UNITED STATES PATENT AND TRADEMARK OFFICE

APPLICATION NO.	FILING DATE	FIRST NAMED INVENTOR	ATTORNEY DOCKET NO.	CONFIRMATION NO.
10/679,570	10/06/2003	Alexander Heilig	TRW(REPA)6762	3141

Office Action Summary	Application No. 10/679,570	Applicant(s) HEILIG ET AL.	
	Examiner SANG KIM	Art Unit 3654

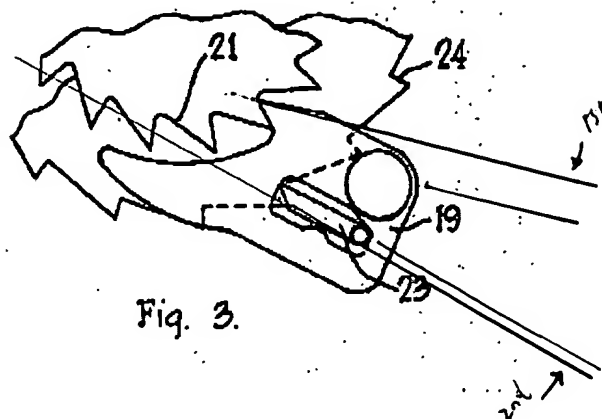
Claims 1-2, 5-8 and 9 are rejected under 35 U.S.C. 102(b) as being anticipated by Heath, U.S. Patent No. 3834646.

With respect to claims 1, 5 and 9, Heath '068 shows a frame (12) and a belt spool (28) mounted in said frame; first and second locking wheels (21, 24) and first and second locking catch (20, 23) engaging respectively and spaced apart (claim 2) able to position into non-locking and locking modes, and a spring (32, see figures 8-10, rotating each disc together and the disk contains first and second wheels) is provided (claim 8), each locking catch has a point of rotation (no reference numbers) and able to swing perpendicularly on each tooth face respectively (no reference numbers) from the point of contact, and the first locking catch (20) runs between said point of rotation and a rotation axis of said belt spool (28), and the second locking catch (23) runs on the side of point of rotation facing away from said rotation axis of said belt spool (28), see figure 1.

With respect to claims 6-7, Heath '646 shows each locking wheel and each locking catch with a different cut (i.e. the teeth for each wheel, as well as each locking catch has its own respective pitch or cut), see figure 1.
